**Comments on
PGE 2009 Integrated Resource Plan
Public Utility Commission of Oregon
Docket No. LC 48**

May 19, 2010

Public Utility Commission of Oregon
Docket No. LC 48
Comments on PGE 2009 Integrated Resource Plan
PUBLIC
Protected Materials Redacted

Figure 1: Natural Gas Prices Used in IRP Modeling Analyses vs. NWPCC, Oregon PUC Staff, AEO 2010 and NYMEX Futures (Levelized in 2009\$)

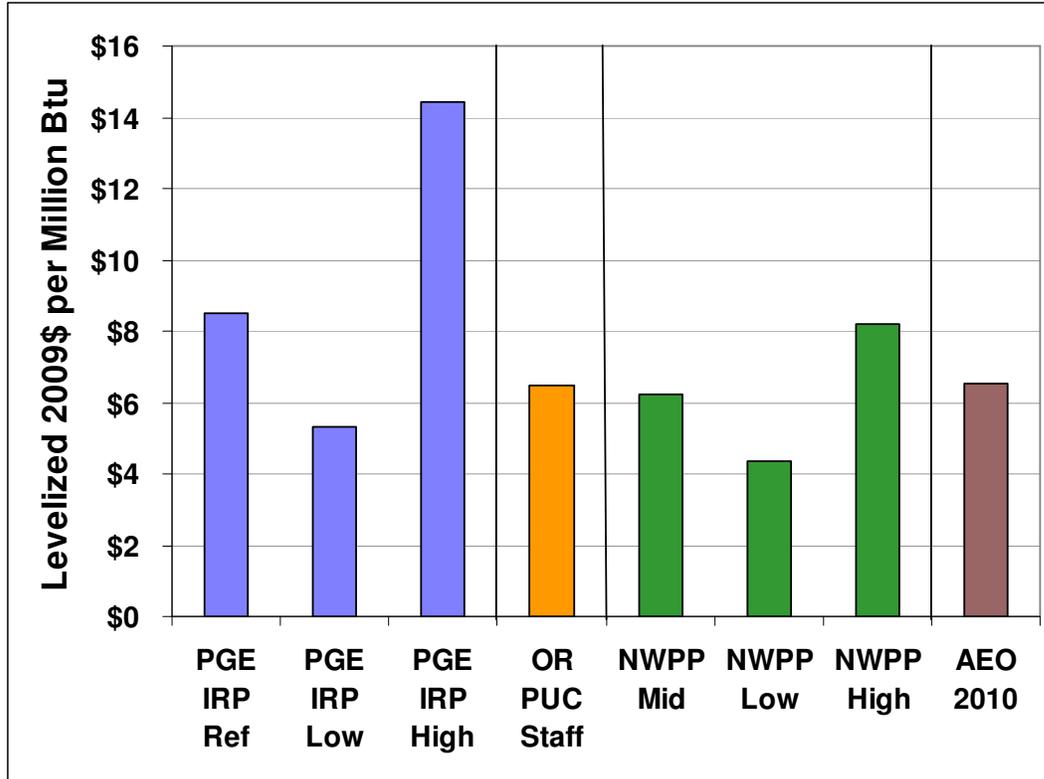
Therefore, it is quite unfortunate that, as can be seen in Figure 1, below, PGE has used natural gas prices in its IRP analyses that are simply not ‘credible.’ Instead, the natural gas prices that PGE used in its IRP are much higher than the future natural gas prices projected by NWPCC, the Oregon PUC staff, and the U.S. Department of Energy’s Annual Energy Outlook for 2010 (“AEO 2010”), as well as current NYMEX futures prices.

Figure 1 shows that:

- The reference case natural gas prices that PGE used in its IRP analyses are significantly higher than Oregon PUC Staff, NWPP mid and AEO Forecasts and NYMEX futures prices.
- PGE’s IRP reference case natural gas prices are actually slightly higher than NWPCC’s *high* gas price forecast.
- PGE’s IRP high natural gas price forecast is dramatically higher than NWPCC high forecast.
- On a levelized basis, the PGE IRP high gas price forecast is 70 percent higher than the PGE reference case forecast while the NWPCC high gas price forecast is only 32 percent higher than the NWPCC mid forecast.

Figure 4: 2010 PIRA Natural Gas Price Forecasts vs. The Gas Prices Used in IRP Modeling Analyses and the NWPPCC, Oregon PUC Staff, AEO 2010 and NYMEX Futures Prices (Levelized in 2009\$)

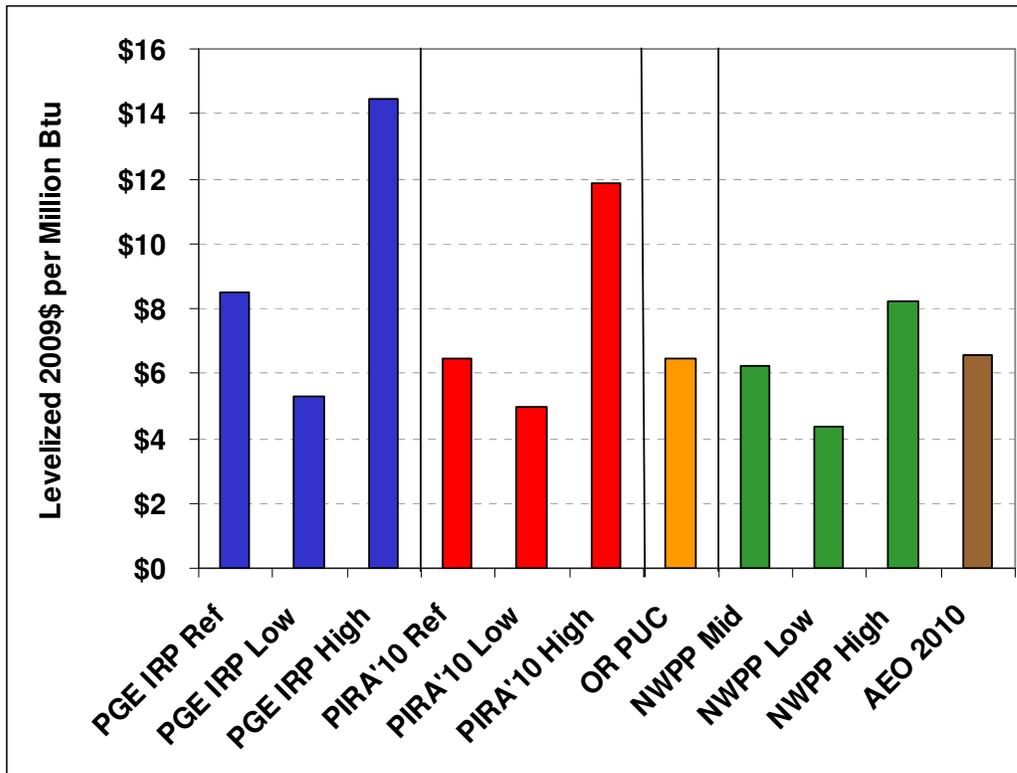
PGE’s May 7, 2010 response to PEAC Data Request Question No. 77 provided PIRA’s new April 2010 reference natural gas price forecast and its new February 2010 high and low gas price forecasts. As can be seen in Figure 4, below, on a levelized basis these forecasts are substantially lower than the gas price forecasts that PGE used in the IRP analyses. The new PIRA forecasts also appear to be much more consistent with the natural gas price forecasts from NWPPCC, AEO 2010 and the Oregon PUC staff.

These new gas-price forecasts confirm our finding that the natural gas prices that PGE used in its IRP analyses were much too high and that the results of those analyses, therefore, are biased against natural gas-fired generation and in favor of the continued operation of the Boardman plant.

Figure 6: PGE Assumed Load Growth vs. NWPC Oregon Forecast²⁰

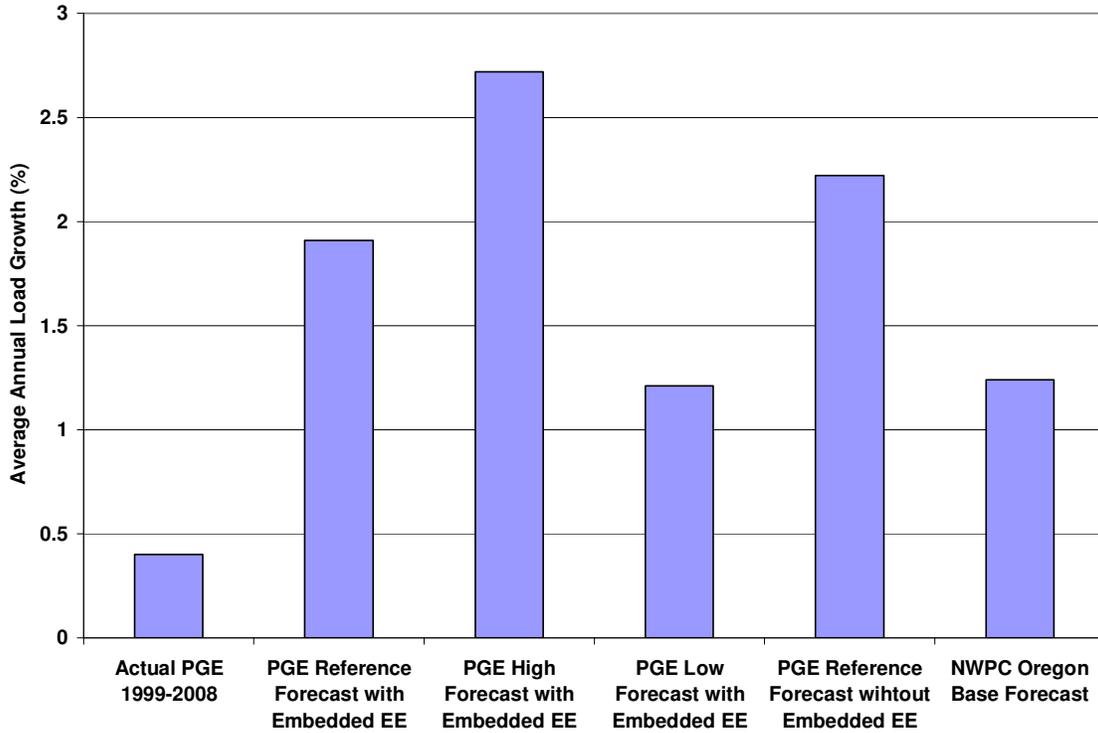
PGE also claims that its energy growth forecasts are consistent with the NWPC’s Draft Sixth Plan forecasts (now adopted as the Sixth Plan Forecasts).¹⁹ However, that claim does not appear to be accurate, as shown in Figure 6, below.

Thus, PGE’s Reference and High Forecasts with Embedded EE and its Reference Forecast without Embedded EE are all significantly higher than the NWPC Oregon Base Forecast. Only the PGE Low Forecast with Embedded EE is comparable to the NWPC Oregon Forecast. Consequently, it is extremely hard to see how PGE’s energy forecasts are ‘consistent’ with those of the NWPC.

Figure 7.a: PGE March 2009 Energy Forecast Used in IRP vs. Company’s December 2009 Forecast

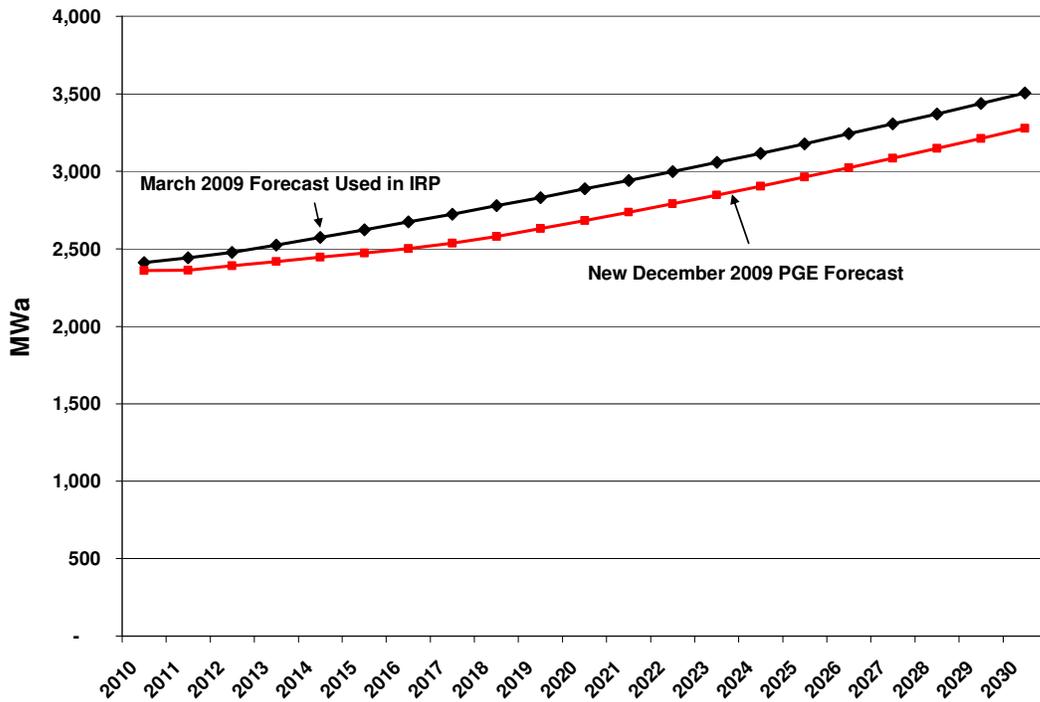
PGE’s May 5, 2010 response to PEAC Data Request Question No. 78 provided the Company’s December 2009 energy and peak load forecasts. As shown in Figures 7.a. and 7.b., below, the new December 2009 forecasts are substantially below the March 2009 load forecasts that PGE used in its IRP modeling.

Even though PGE has only slightly reduced its projected long-term 2010-2030 average energy and peak load growth rates,²² the annual reductions are significant as shown in Figures 8.a. and 8.b. below, and reduce PGE’s need for the capacity and energy from the Boardman plant.

Figure 8.a.: Annual Reductions in PGE Energy Load Forecasts between March 2009 Forecast Used in IRP and December 2009 Forecast

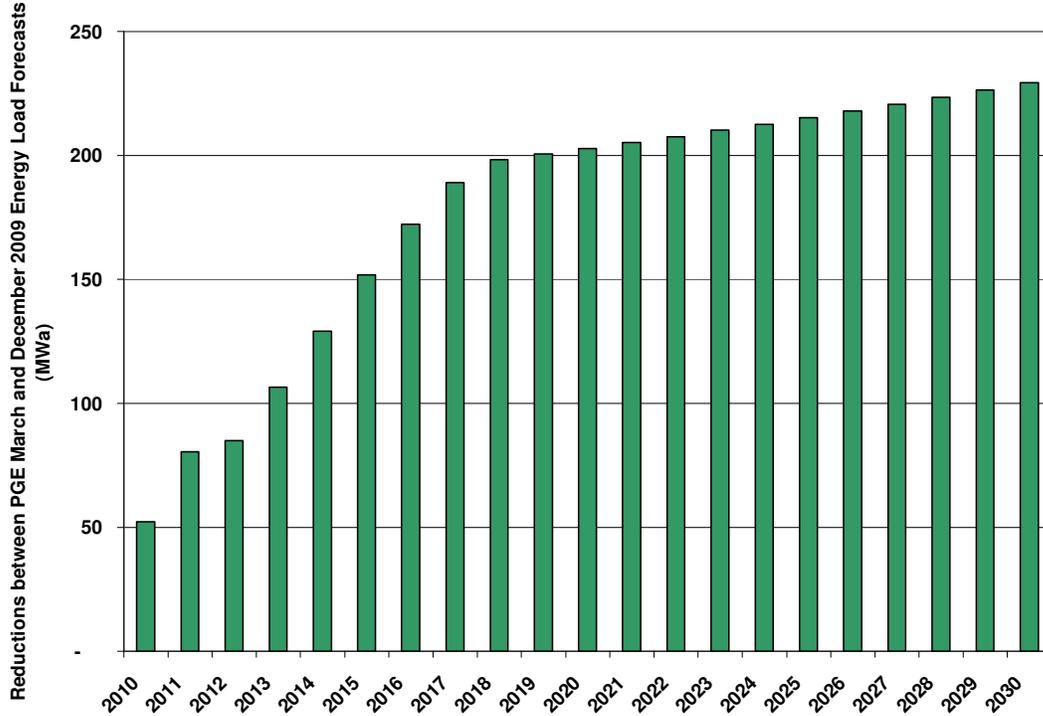
Consequently, PGE has reduced the energy forecast used in its reference case IRP analyses by between 5.8 percent in 2015 to 6.5 percent in 2030. PGE similarly has reduced the peak load forecast used in its IRP analyses by 3.8 percent in 2015 increasing to 4.6 percent in 2030. It is reasonable to expect that these reductions in energy and peak loads substantially affect PGE’s need for the energy and capacity from the Boardman plant. However, we have not seen any evidence that PGE has rerun its IRP analyses in light of its December 2009 forecasts.

Figure 9: Annual PGE CO₂ Emissions in Diversified Thermal with Green and Boardman through 2014 Portfolios with Reference Case CO₂ Prices

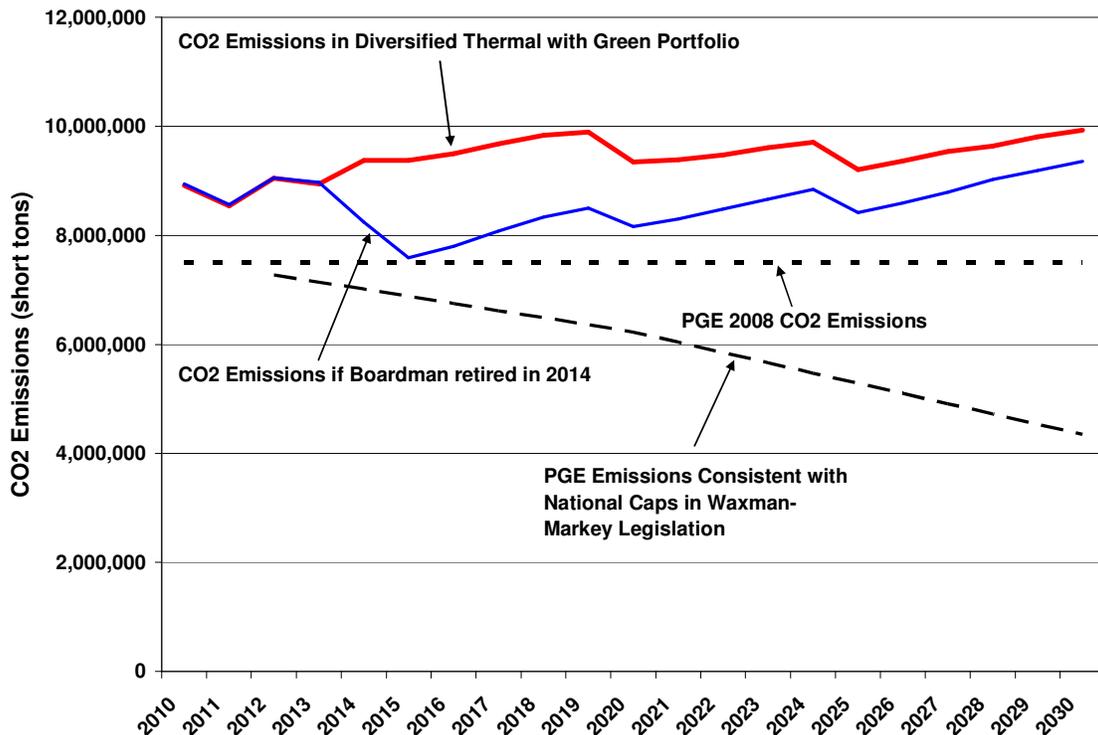
PGE is to be commended for examining a fairly wide range of CO₂ prices in its IRP modeling analyses. However, as shown in Figures 9 and 10, below, the results of those analyses show that the Company’s annual CO₂ emissions in both the Diversified Thermal with Green (i.e., Boardman through 2040) and the Boardman through 2014 portfolios will be significantly higher in 2030 than they were in 2007 – although the annual emissions in the Boardman through 2014 portfolio would be substantially lower than in the Diversified Thermal with Green portfolio.

A comprehensive system for federal regulation of CO₂ and other greenhouse gases is inevitable. It is generally expected that this federal regulation will require steep reductions in greenhouse gas emissions. However, as shown in Figures 9 and 10, PGE's IRP analyses show that its annual CO₂ emissions will increase over time, not decrease. Consequently, PGE's projected future CO₂ emissions would be in conflict with evolving state, regional and national climate policies.

Figure 11: NPVRR of Diversified Thermal with Green Portfolio in PGE CO₂ Price Scenarios

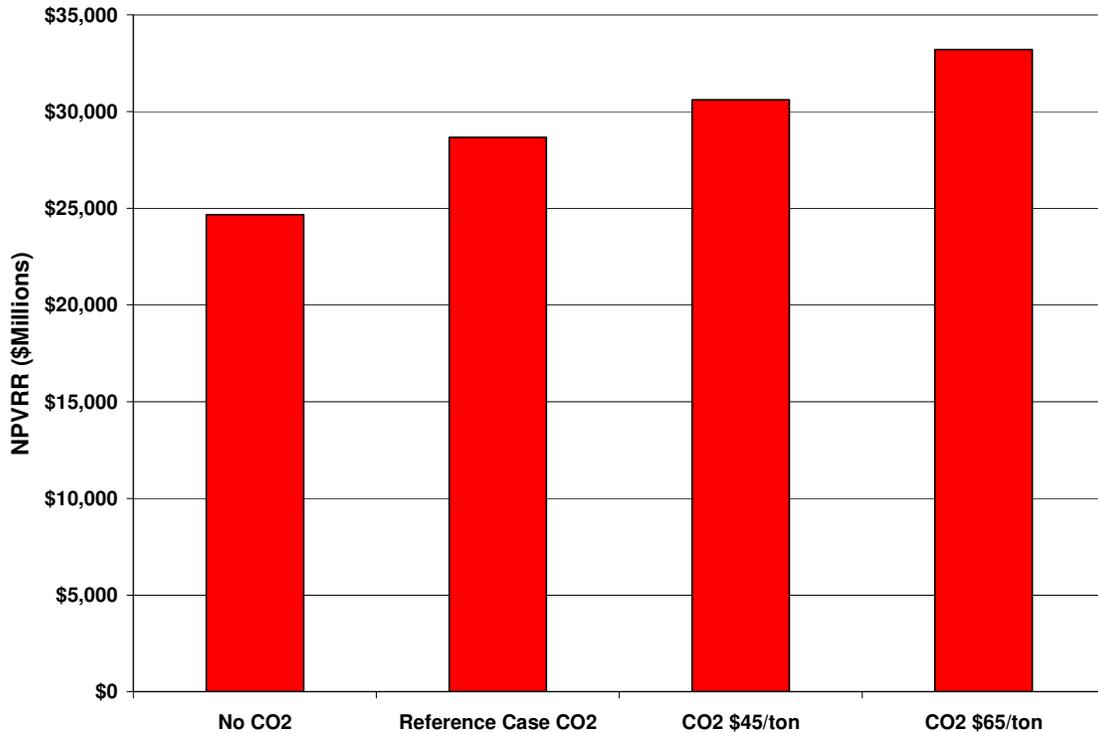
Moreover, ratepayers will face significant financial risk associated with a decision to lock in increasing CO₂ emissions for the coming decades at a time when those emissions will be costly. This financial risk is quite substantial as is illustrated in Figure 11, below,

Thus, the NPVRR of the Diversified Thermal with Green portfolio could increase by as much as 35 percent, or approximately \$8.5 billion, depending on how CO₂ prices actually evolve over time.

Figure 12: NPVRR of Early Retirement and Boardman through 2040 Portfolios with PGE Reference Case Gas Prices

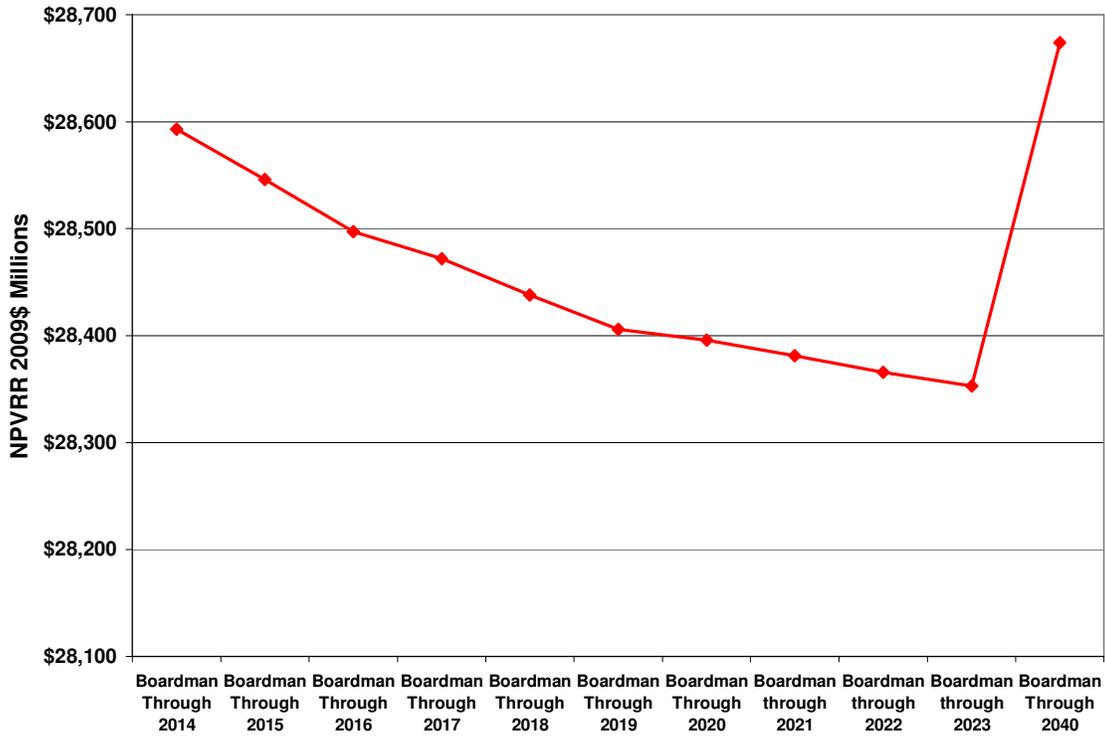
Figures 12 and 13, below, compare the NPVRR from PGE's Aurora model runs for the scenarios in which the Boardman plant is retired in each of the years 2014 through 2023 and 2040. Although the NPVRR in Figure ... are biased by the same assumptions that have been discussed above (e.g., extremely high gas prices, replacement of Boardman by a gas-fired combined cycle unit, and high forecast energy and peak loads), the Company's modeling showed that the NPVRR of each of these early retirement portfolios was lower than the \$28,674 (in 2009\$ millions) NPVRR of PGE's Diversified Thermal with Green portfolio that assumes continued operation of Boardman through 2040.

Figure 13: NPVRR of Early Retirement and Boardman through 2040 Portfolios with PGE Low Case Gas Prices

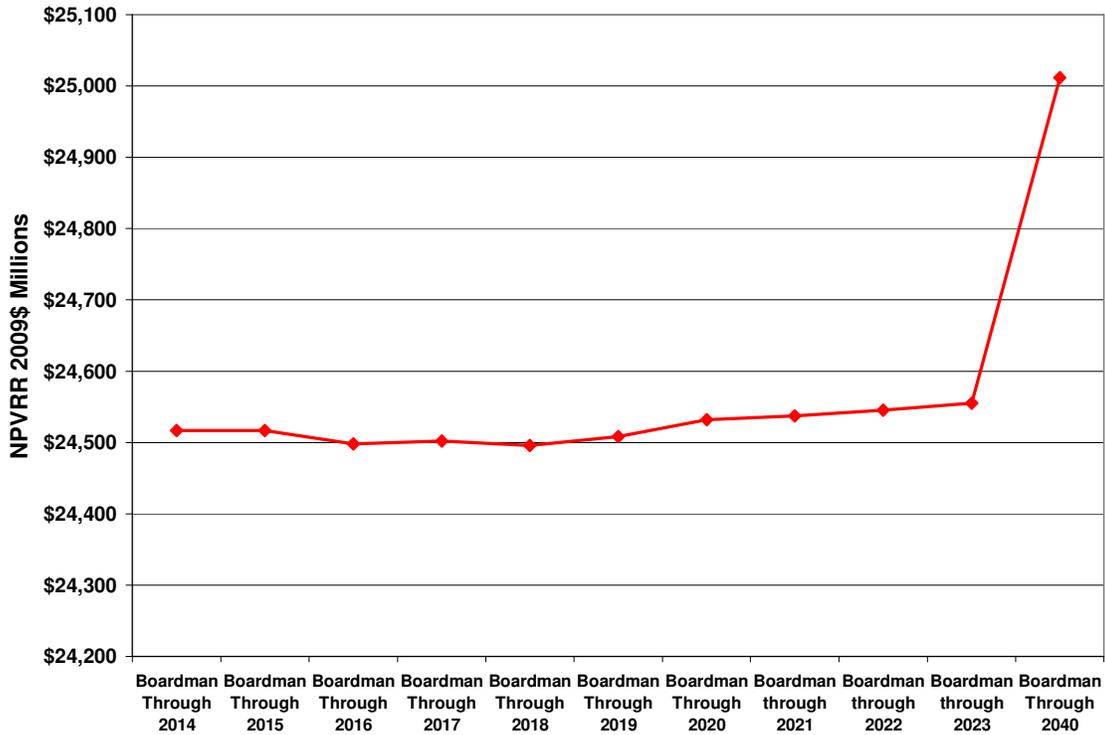
Figure 13 then presents the same comparison but reflects the low gas prices that PGE used in the IRP analyses. These low gas prices are more comparable to the base or reference gas price forecasts from the NPWCC, the Oregon PUC staff and others than PGE’s Reference or High IRP gas price forecasts.

Consequently, the Company’s own modeling analyses show that retirement of the Boardman plant in any of the years between 2014 and 2019 is a lower cost option than continued operation through 2040 even with the biased assumptions discussed earlier in these comments. Indeed, when less biased, and more reasonable, gas prices are used, continuing to operate the Boardman plant through 2040 (i.e., the Diversified Thermal with Green portfolio) can be seen to be significantly more expensive than any of the early retirement portfolios.

Figure 14: NPVRR Difference between PGE Diversified Thermal with Green and Boardman through 2014 Portfolios (2009\$ Millions)

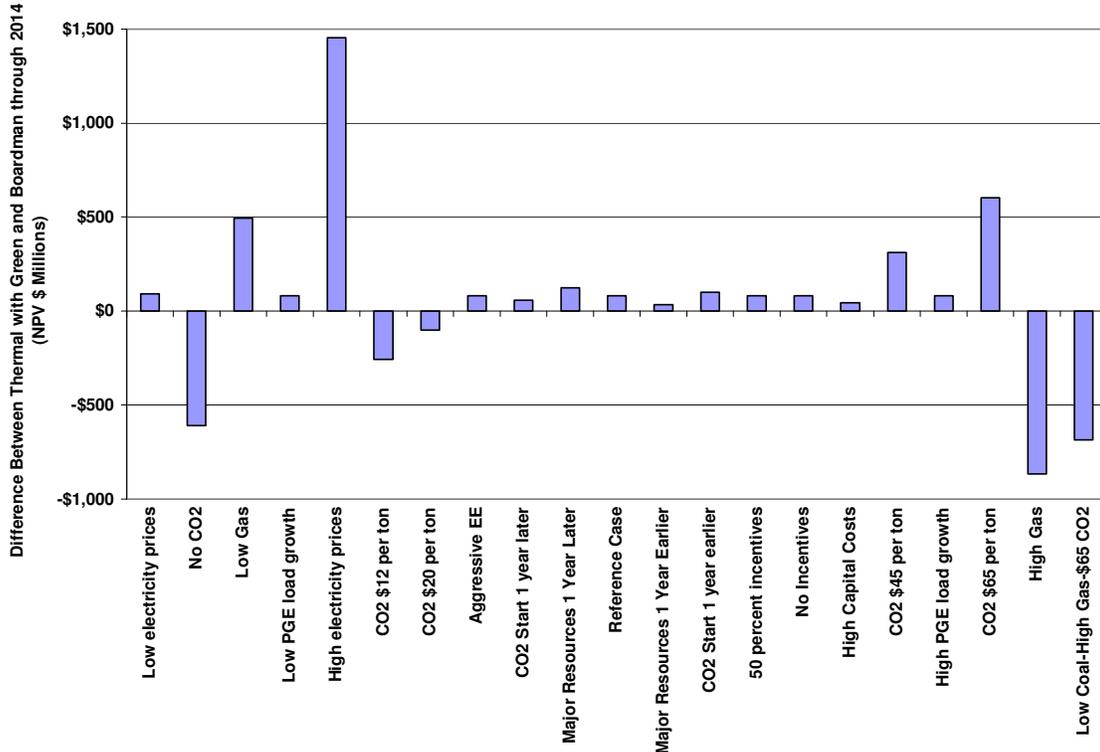
Figure 14, below, shows the NPVRR differences between the Boardman through 2014 and the Diversified Thermal with Green portfolios in each of the 21 futures scenarios modeled by PGE for the IRP. The Diversified Thermal with Green portfolio is the more expensive option in 16 of the 21 scenarios modeled by PGE.

It is important to recognize that the five scenarios in which the Diversified Thermal with Green portfolio is the lower cost option include the two scenarios with completely unrealistic high gas prices and the three scenarios with no CO₂ prices or low CO₂ prices – and the Diversified Thermal with Green portfolio is only significantly lower cost than the Boardman through 2014 portfolio in the more unrealistic scenarios with high gas prices and no CO₂ prices. Thus, in order to accept that the Diversified Thermal with Green portfolio is a lower cost option than retiring Boardman in 2014 it is necessary to accept either that gas prices will be dramatically higher than anyone now projects, that there will be no federal regulation of greenhouse gases at any time between 2010 and 2040 or that federal regulation will lead only to low CO₂ prices.

Figure 15: Net Present Value Revenue Requirement Benefit to Retiring Boardman in 2014 as Compared to Operating the Plant through 2040 with PGE Reference and Low Gas Prices

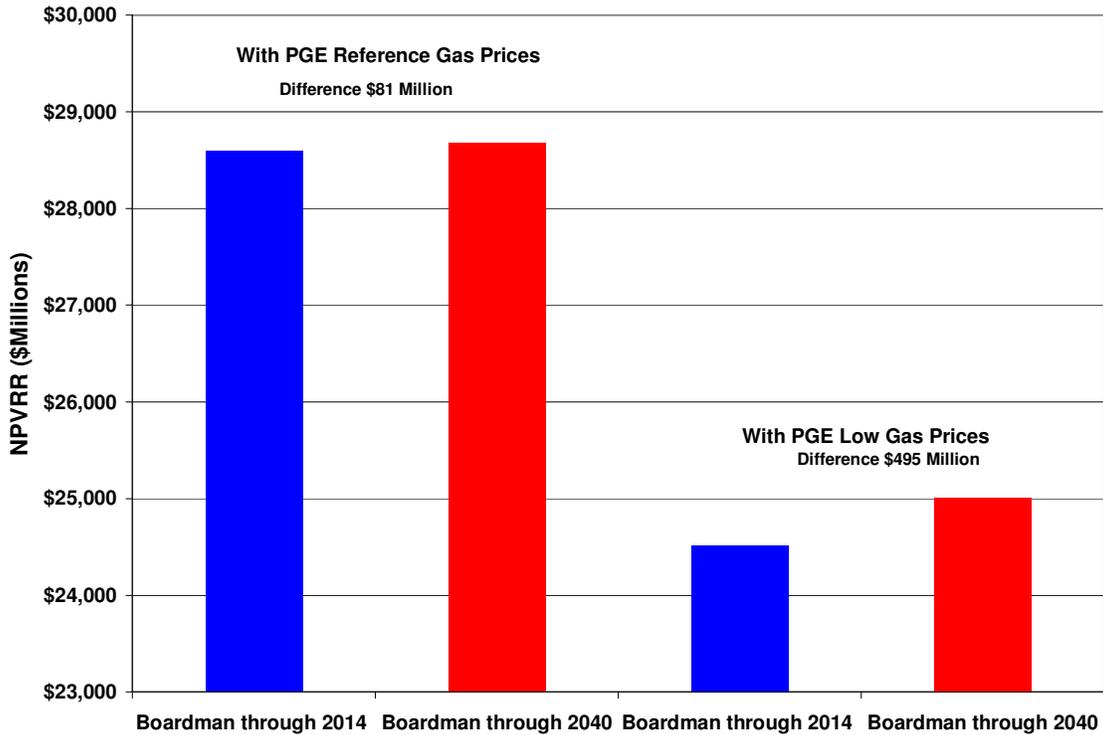
On the other hand, as shown in Figure 15, below, the NPVRR benefit to the Boardman through 2014 portfolio increases to \$495 (2009\$ Millions) in PGE’s low gas price future scenario. This is a more reasonable scenario in which the assumed gas prices are only slightly lower than the current mid NWPCC forecast, the Oregon PUC staff forecast, the AEP 2010 forecast and current NYMEX futures.
